**Meridian Airport Authority, Dean Aircraft Services
Hangar Additions & Alterations**

ADDENDUM NO. 2

TO: All Bidders on the Above Referenced Product
FROM: Davis Purdy Architects, PLLC
DATE: March 12, 2020
SUBJECT: **ADDENDUM NO. 2**

S-105R

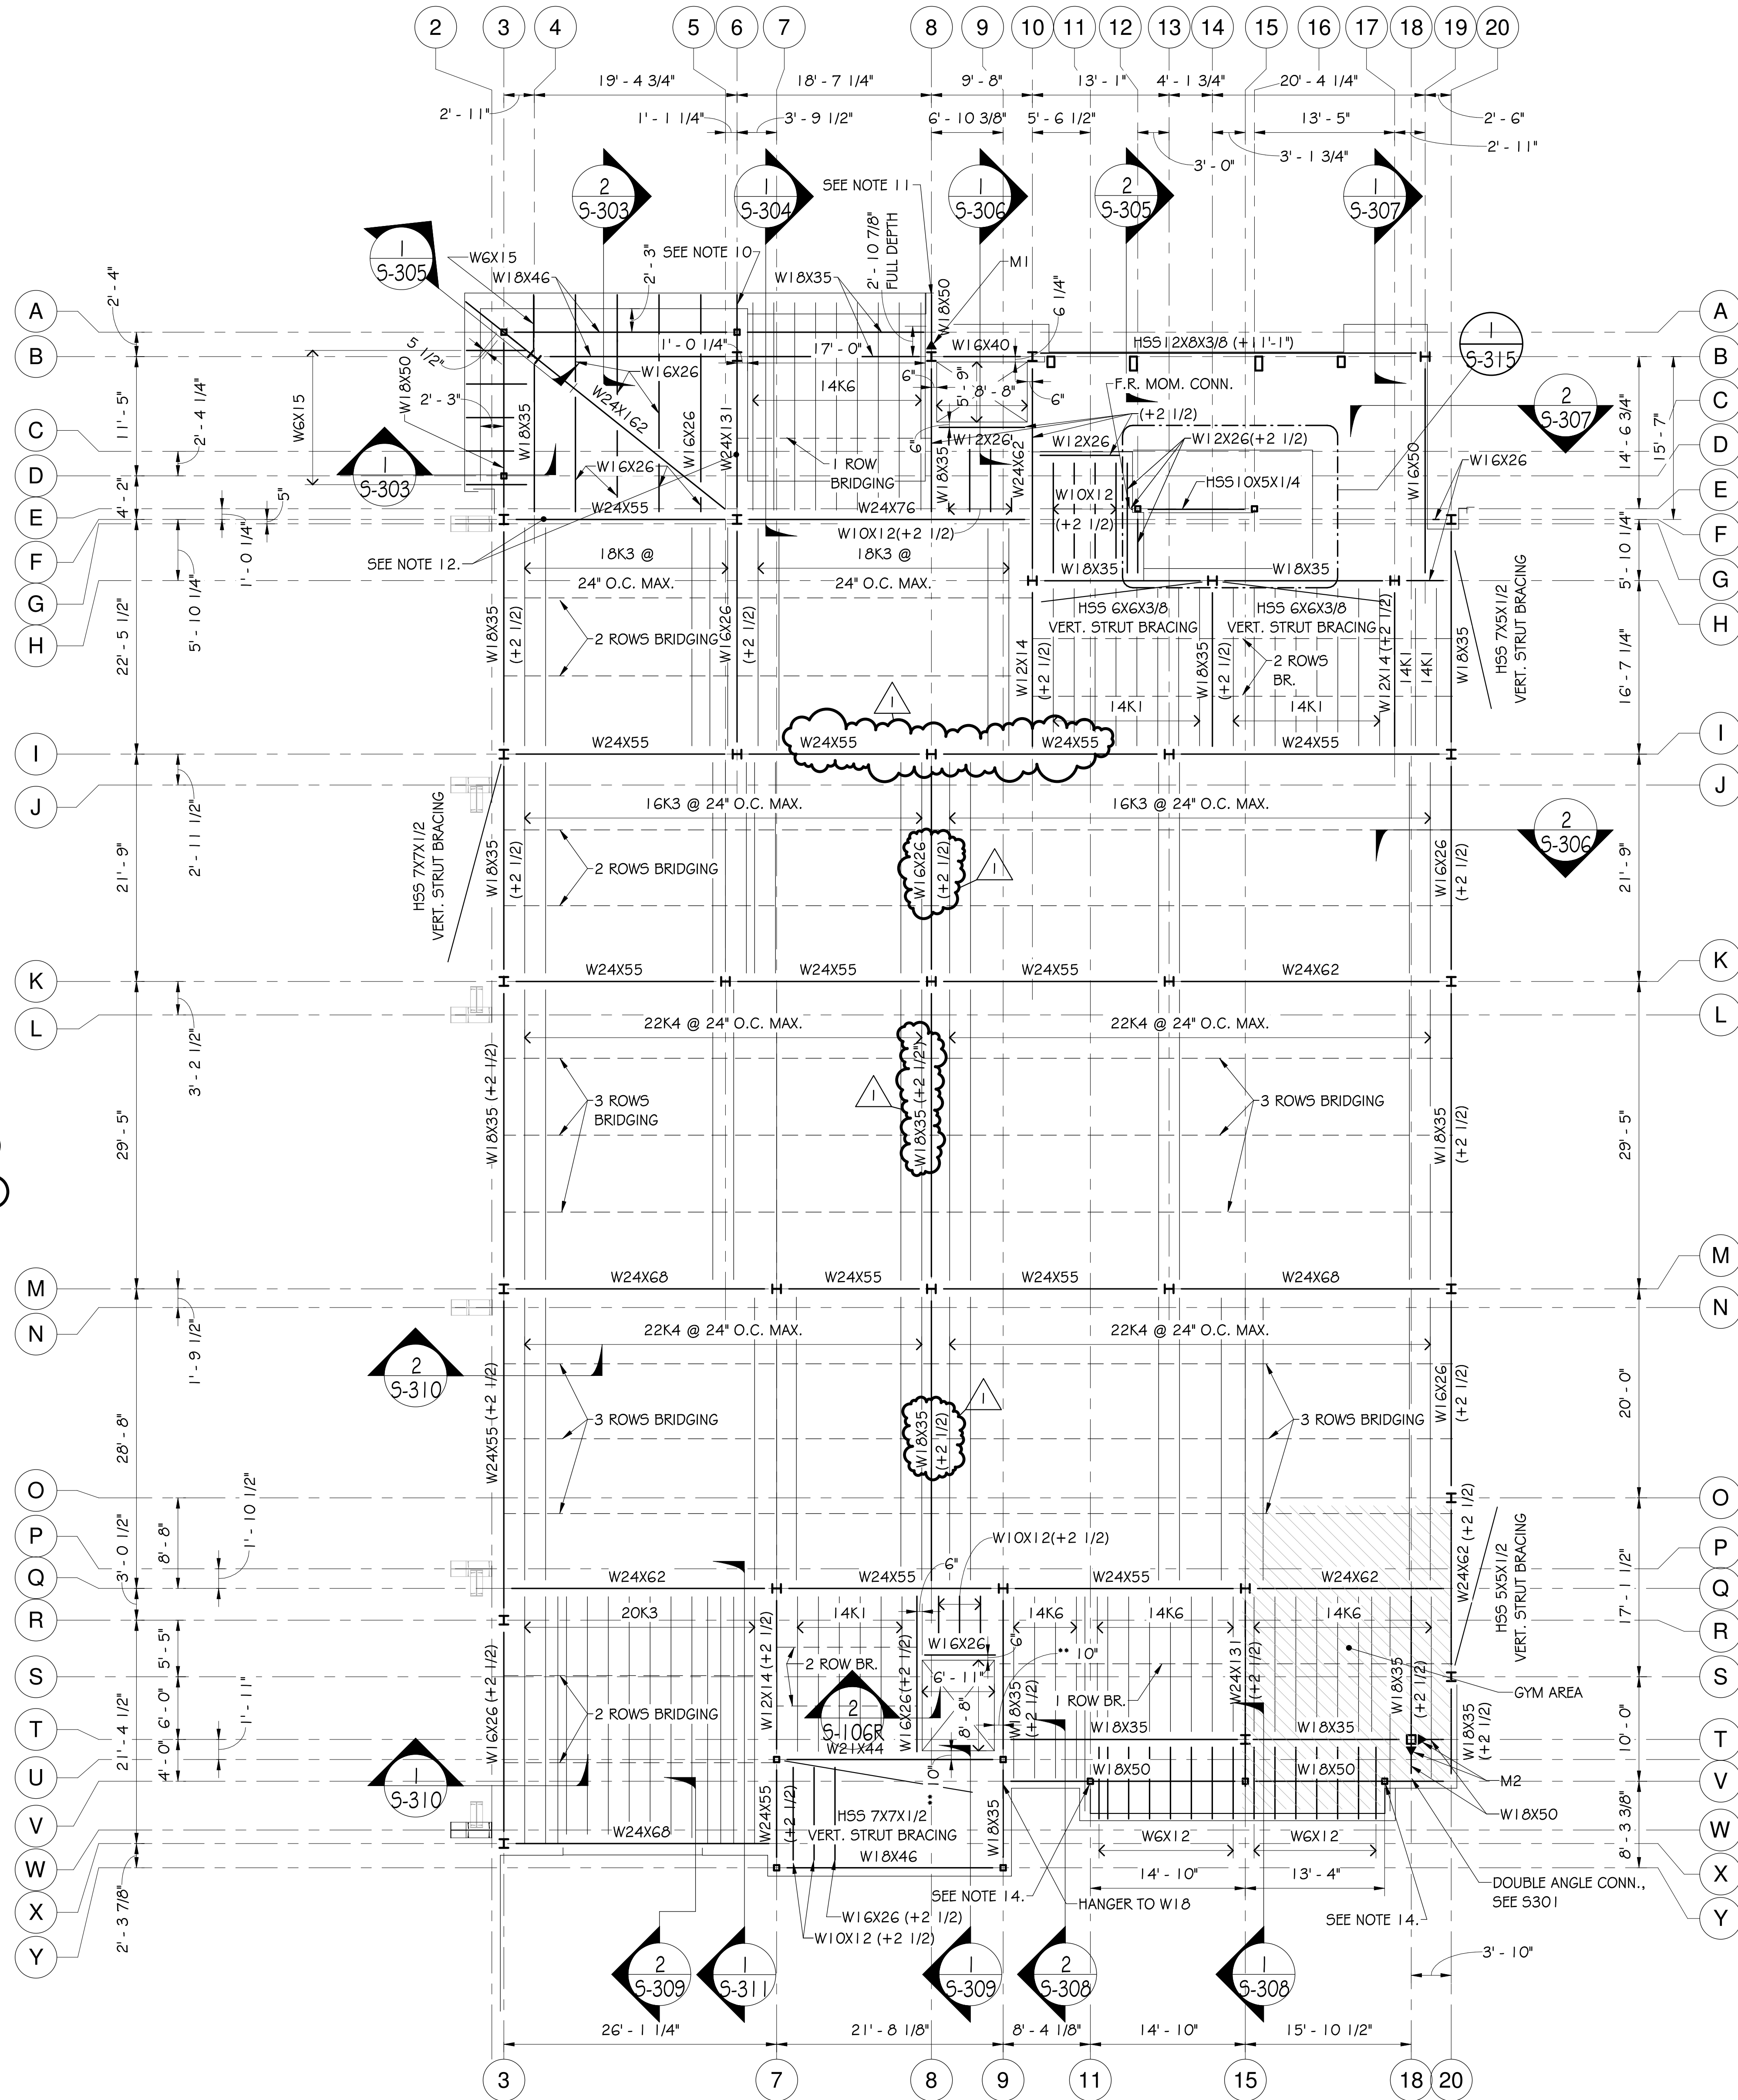
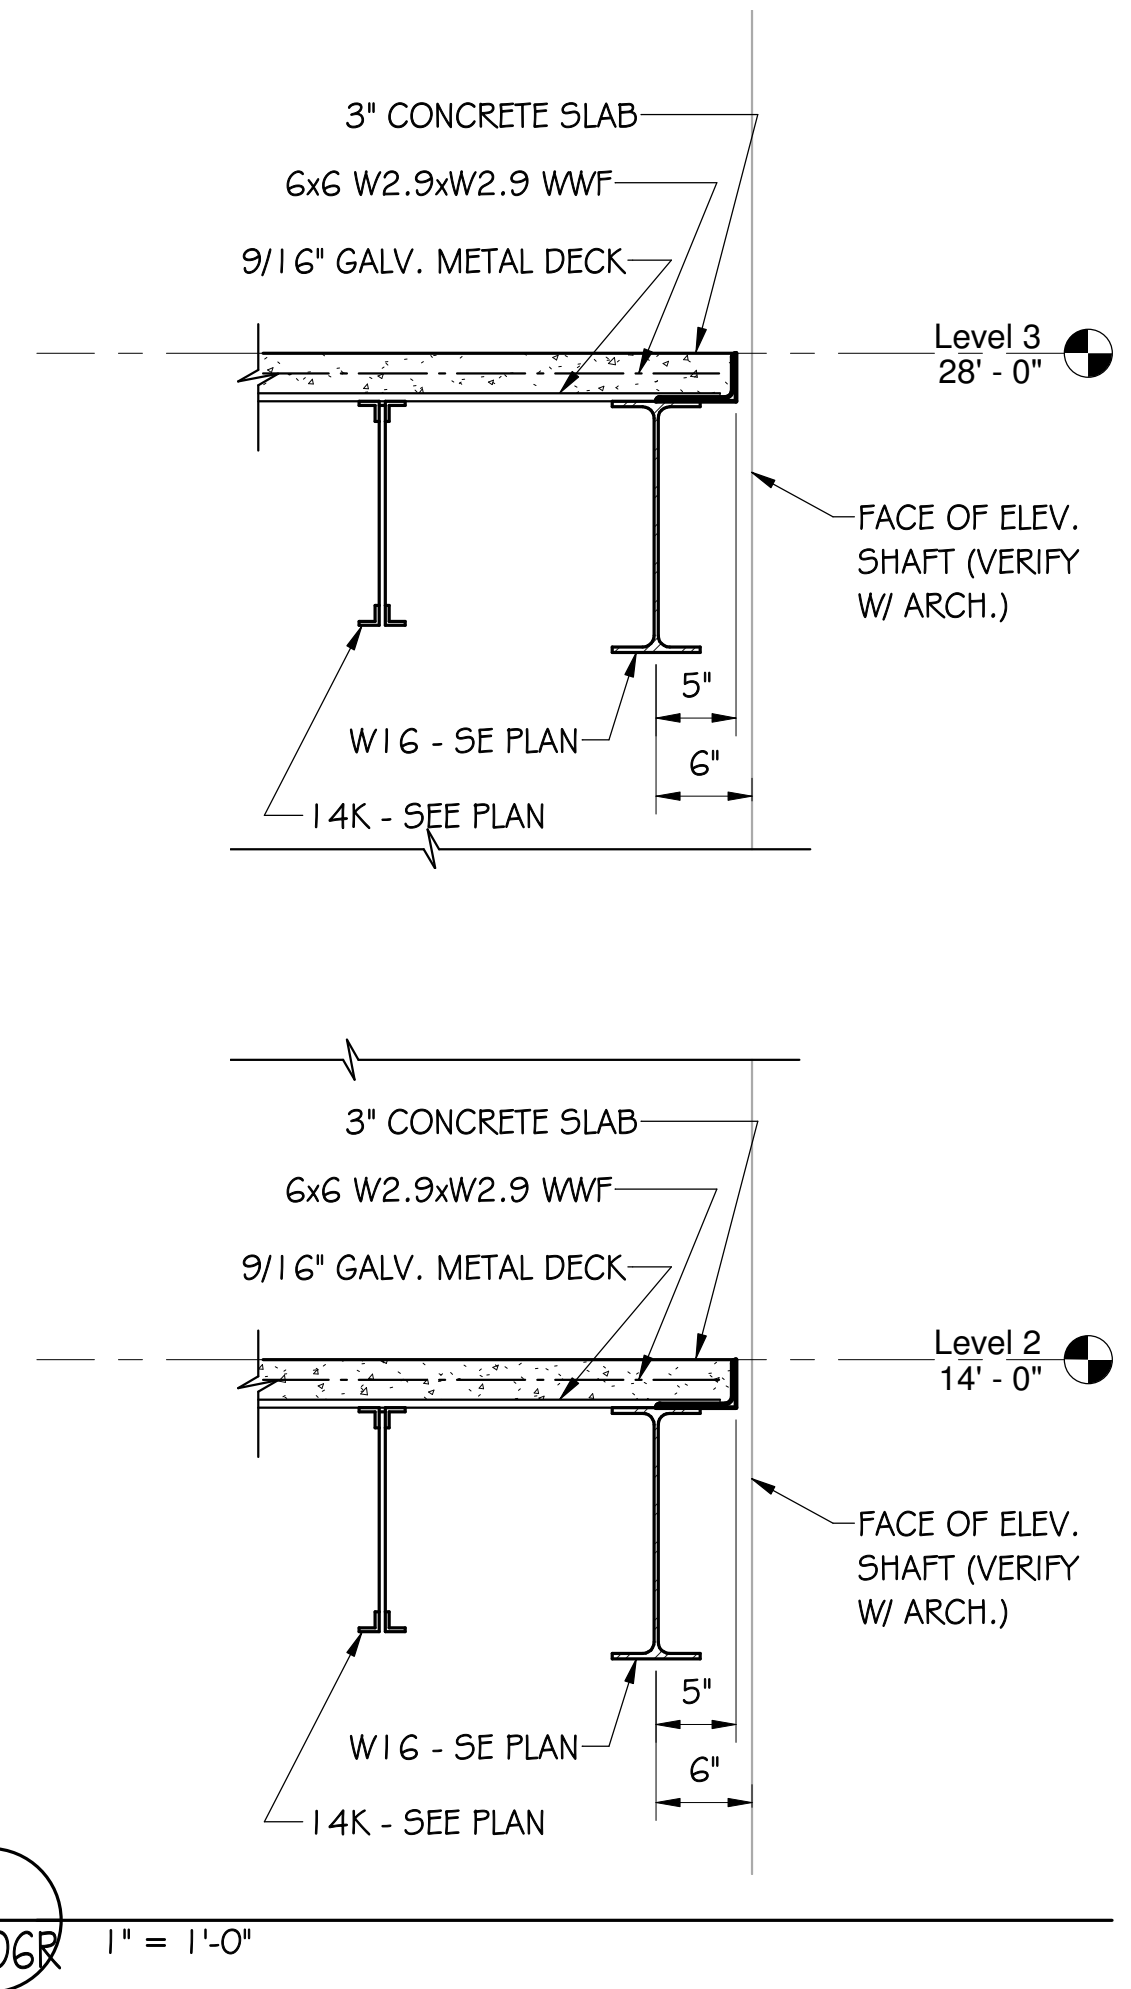
- a. **S-105** FOUNDATION FRAMING PLAN – OFFICE ADDITION, replace with S-105R
- b. **S-106** SECOND FLOOR FRAMING PLAN – OFFICE ADDITION, replace with S-106R
- c. **S-107** THIRD FLOOR FRAMING PLAN – OFFICE ADDITION, replace with S-107R
- d. **S-108** ROOF FRAMING PLAN – OFFICE ADDITION, replace with S-108R

- a. **S-105R** FOUNDATION FRAMING PLAN – OFFICE ADDITION
- b. **S-106R** SECOND FLOOR FRAMING PLAN – OFFICE ADDITION
- c. **S-107R** THIRD FLOOR FRAMING PLAN – OFFICE ADDITION
- d. **S-108R** ROOF FRAMING PLAN – OFFICE ADDITION.
